WBS: 12.201811
COUNTY: Catawba
ROUTE: SR 2303, SR 1615, SR 1659, SR 3008
DESCRIPTION: Head/End Walls, Pipe Replacement, Paving, Pumping, and
Erosion Control

SUBJECT: Addendum #1 - Pre-Bid Conference Minutes

Map #1

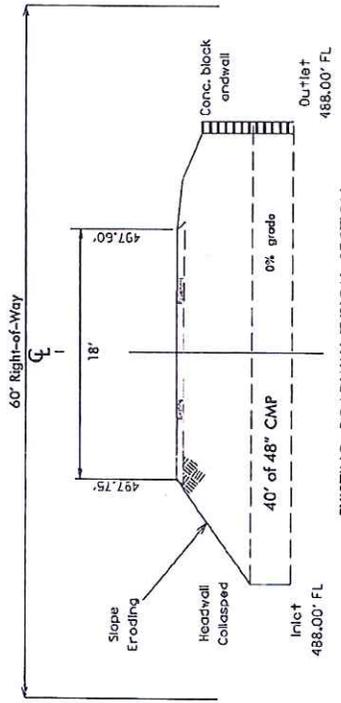
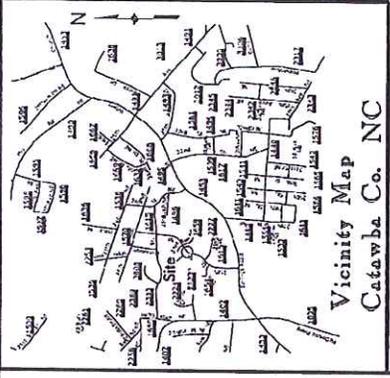
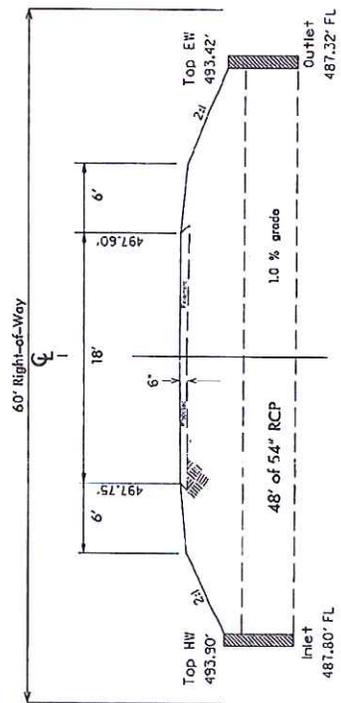
- Reviewed the Preparation and Submission of Bids provision on page 20 of the contract proposal
- Utility Conflicts on page 21 of the contract proposal
- Mandatory Subcontractor Information on pages 36-37 of the contract proposal
- Bypass Pumping on page 45 of the contract proposal
- Borrow and Waste Site Reclamation Procedures on page 47 of the contract proposal
- Erosion and Sediment Control/Stormwater Certification provision on pages 50-55 of the contract proposal
- Temporary Traffic Control on pages 59-62
- Permits on page 63 and in the plan package of the contract proposal
- Sheet #1 was not included in the original bid package. It is attached hereto.

- What is the required pavement structure?
 - Answer – Per the plans, the pavement structure is 4” B25.0B and 2” S9.5B. Please be advised that the bid sheet included with the original contract proposal did not contain a line item for B25.0B, but it had I19.0B instead. **The bid sheet has been revised to include a line item for B25.0B and to delete the line item for I19.0B and is attached hereto. Please make sure to use the revised bid sheet when submitting bids.**

Proposed Pavement Structure
 4" Asphalt Base Course, Type B 25.0B
 2" Asphalt Surface Course, Type S9.5B
